January 27, 2023

Re: 4401 Alexander Blvd NE
Site Plan – DRB Re-Submittal
Project Number: PR-2018-001252
Application Number SI-2022-02328

Re: Curia Building Addition
4401 Alexander Blvd NE Albuquerque, NM 87107
Grading and Drainage Plan (F16D003B1)
Letter of Response

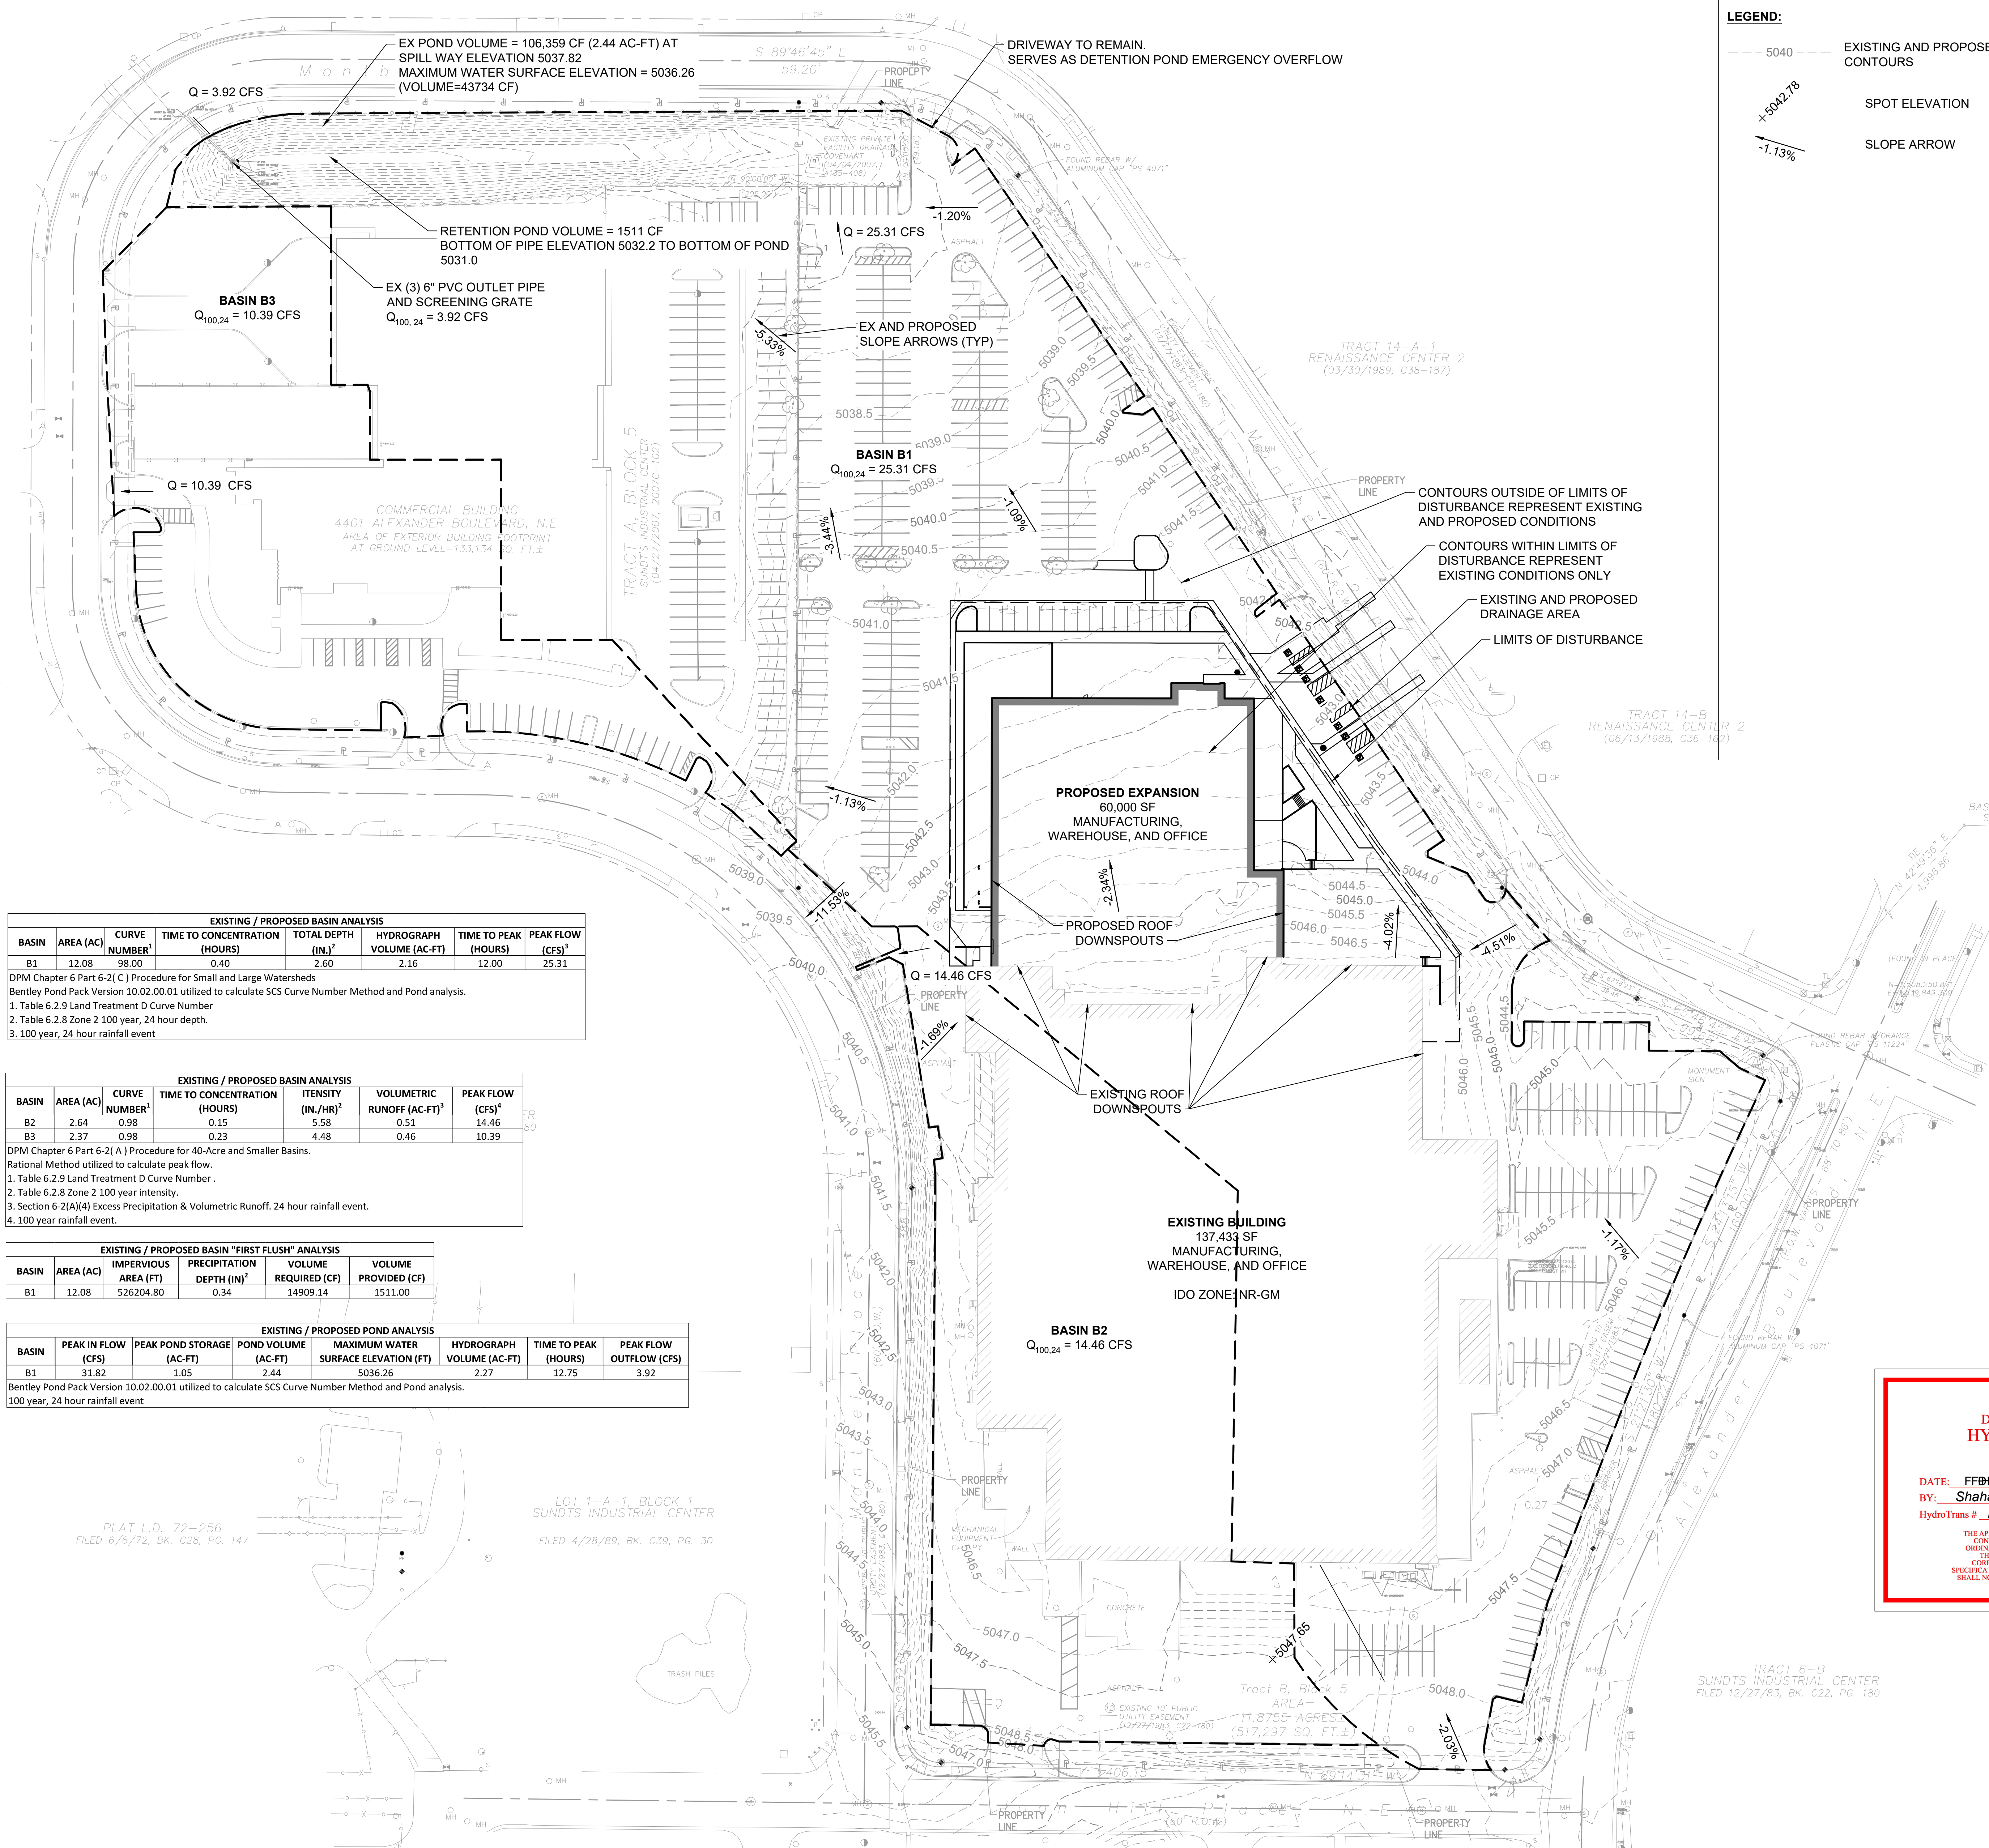
- 5) First Flush Volume requirement calculations must be provided. How will the first flush volume requirement be handled?
First Flush Volume calculations are included in CG101 Overall Grading & Drainage Plan. The existing / proposed detention pond retains the First Flush within

- 6) If the existing pond is going to be modified a new Pond Maintenance & Covenant must be provided. Since most of the existing pond falls within the adjacent site, is there an existing pond easement to allow this site drains to it.
The existing pond will not be modified.

GRADING, AND RESULTANT CHANGE IN TOPOGRAPHY, SHALL NOTE TAKE PLACE IN THIS PROJECT. PROPOSED BASIN ENGINEERING PARAMETERS ARE EQUAL TO EXISTING BASIN ENGINEERING PARAMETERS. THE EXISTING POND DOES NOT REQUIRE MODIFICATION TO RETAIN "FIRST FLUSH" RUN OFF.

| DRAWING NUMBER: CG102 | SIZE: E1 | BUILDING 4401 ENLARGED SITE GRADING PLAN |

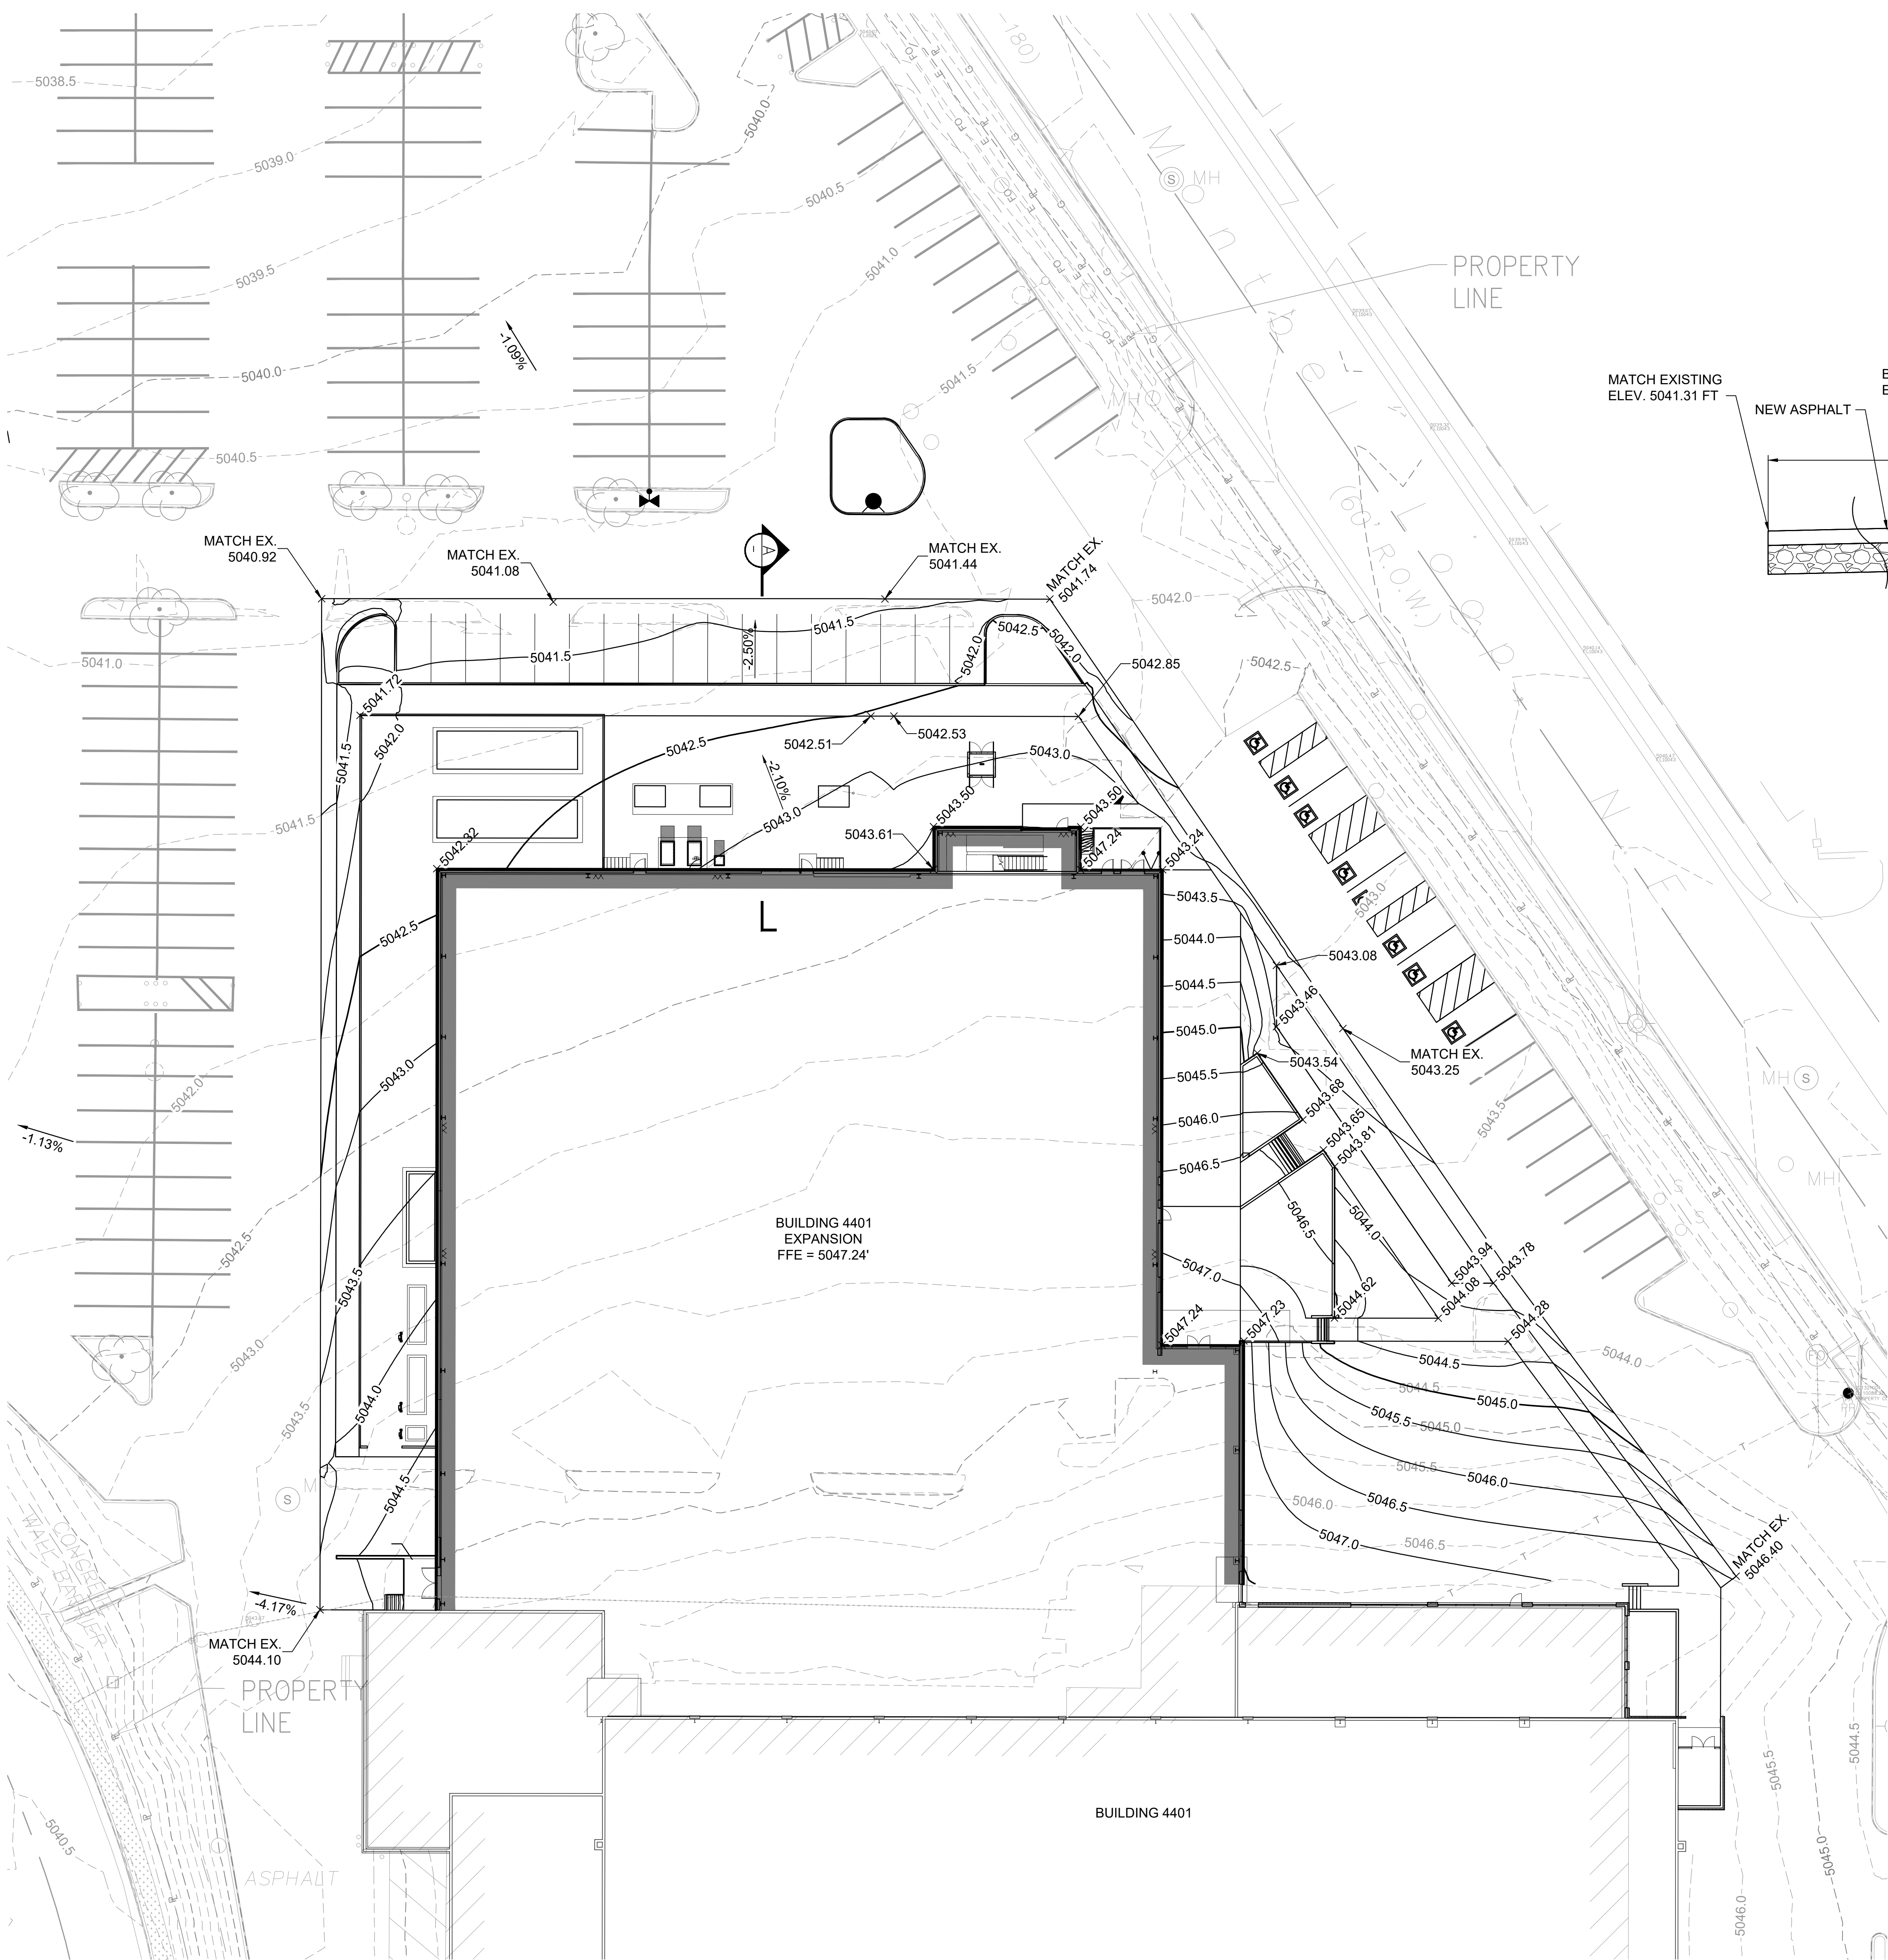
- 4) Provide detail elevation and finished contours around the building and beyond to show how it will tie to the existing grades. To the north the Finished Floor elevation is nearly 6' about the exiting grade. Are there going to be stem walls. Provide cross-sections.
Finish grade and cross section are included on drawing CG102 Enlarged Grading & Drainage Plan.
